Date: **July, 1989**

Subject: **HIGH FLUTTER WHEN USING "EXT SRC" INPUT**

Model: **APR-5001/5002/5003**

Figure 1

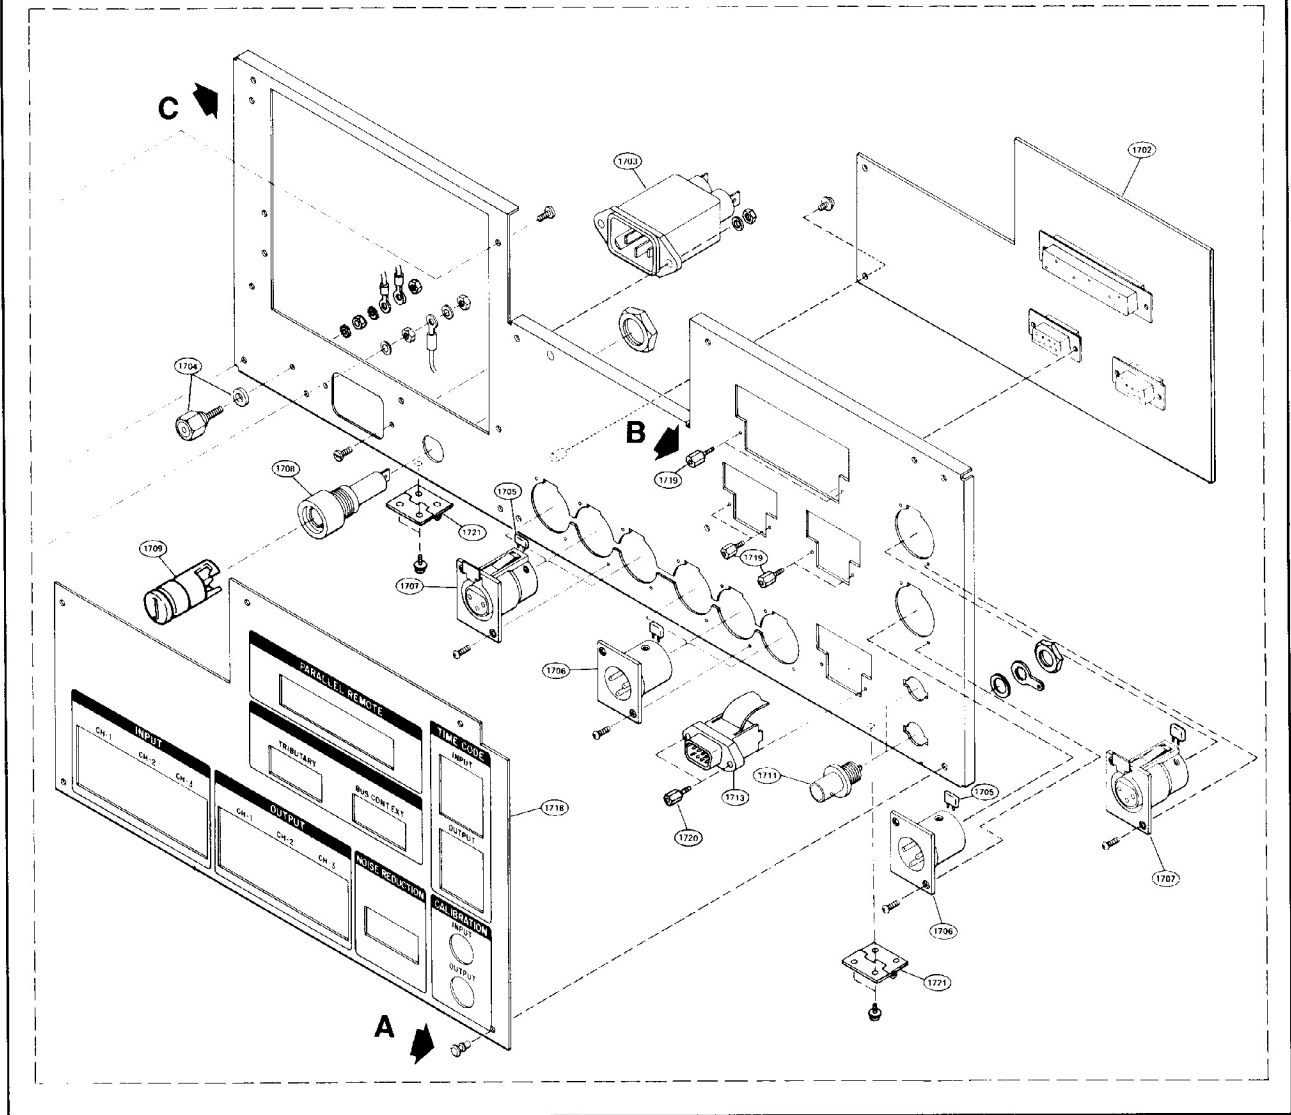
1. To access the CNX Board, first remove five pop-in fasteners on rear panel (A).
2. Remove hex screws (6) located on rear panel (B).

3. Open lower rear panel by removing screws (2) located in upper left- and right-hand corners (C). (See Figure 1.)
4. Remove CNX board by first removing screws (2) holding board in place (A). (See Figure 2.)
5. Push connectors out through cutouts so CNX Board can clear lip of outer panel when being lifted out.
6. If CNX board is numbered T-9412-316-1, it will have a 5-pin resistor network (RN1) instead of discrete resistors at R80 and R81. If so, remove IC7 (HCPL-2730) and replace with HCPL-2531 (T-9413-636-1). No resistor changes are needed.
7. If CNX board is numbered T-9412-316-2 through T-9412-316-4, or 1-619-162-11, proceed with steps a and b.
 - a. Remove IC7 (HCPL-2730) and replace with HCPL-2531 (T9413-636-1).
 - b. Remove R80 and R81 (470Ω) and replace with 4.7kΩ resistors.
8. Reinstall CNX Board by repeating steps 1 and 2 in reverse order.
